Video Products Technical Bulletin 30-2008-106

SUBJECT: MANUAL CORRECTION—C632 ON G BOARD

MODEL: PVM-14L5
 PVM-14L5/1
 PVM-14L5/2
 PVM-14L5/3
 PVM-14L5/4
 PVM-20L5
 PVM-20L5/1
 PVM-20L5/2
 PVM-20L5/3
 PVM-20L5/4
PVM-D14L5A
PVM-D14L5A/1
PVM-D14L5A/2
PVM-D14L5A/3
PVM-D20L5A
PVM-D20L5A/1
PVM-D20L5A/2

PVM-14L5, PVM-20L5, PVM-D14L5A, PVM-D20L5A Service Manual, 1st Edition (Rev. 1)

Figure 1

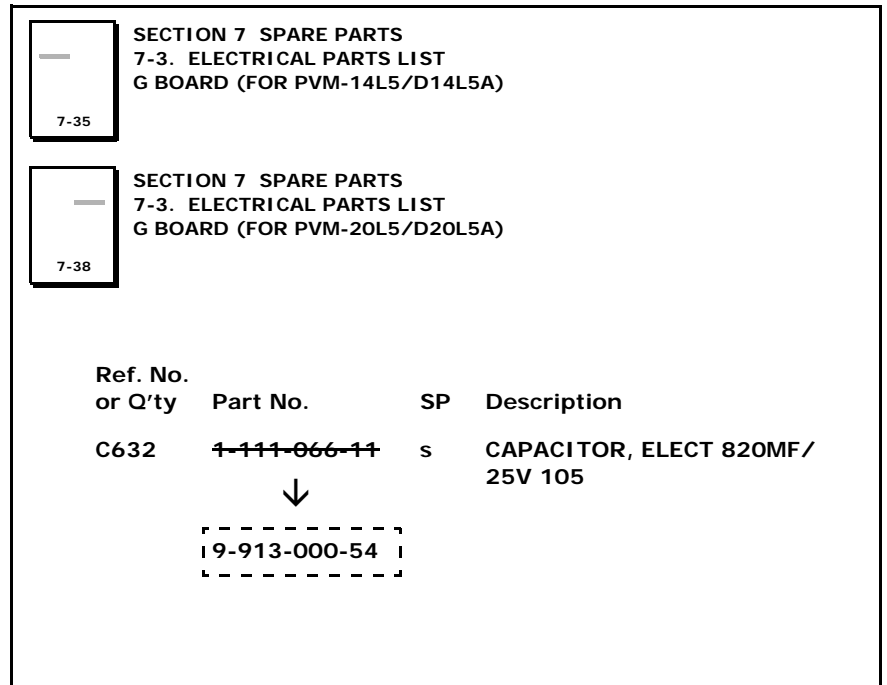
Correct the following manual as shown in Figure 1.

- When replacing C632 (820 μF/25V, 105) on the G board, order part number 9-913-000-54.
- Do not order part number 1-111-066-11 (as specified in the service manual), which is too large and may contact nearby heat-dissipating parts, resulting in damage.
- Do not order original part number 1-115-787-11 because the capacitor with part number 1-111-066-11 will be supplied automatically as a substitute.
- The capacitor 9-913-000-54 is equivalent to the original capacitor 1-115-787-11. (See Figure 2.)

Figure 2

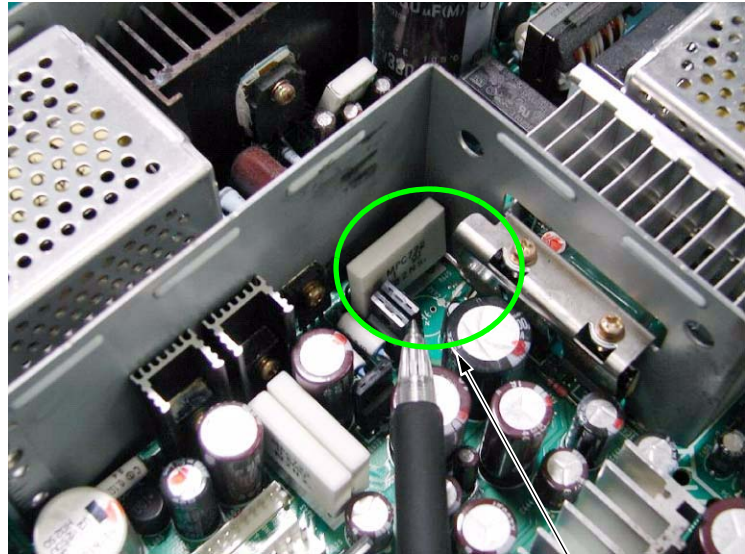
DO NOT USE

ORIGINAL CAPACITOR
820 µF/25V, 105°C
(10 mm DIAMETER x 30)

CAPACITOR IN SERVICE MANUAL
(1-111-066-11)
820 µF/25V, 105°C (12.8 mm DIAMETER x 20)
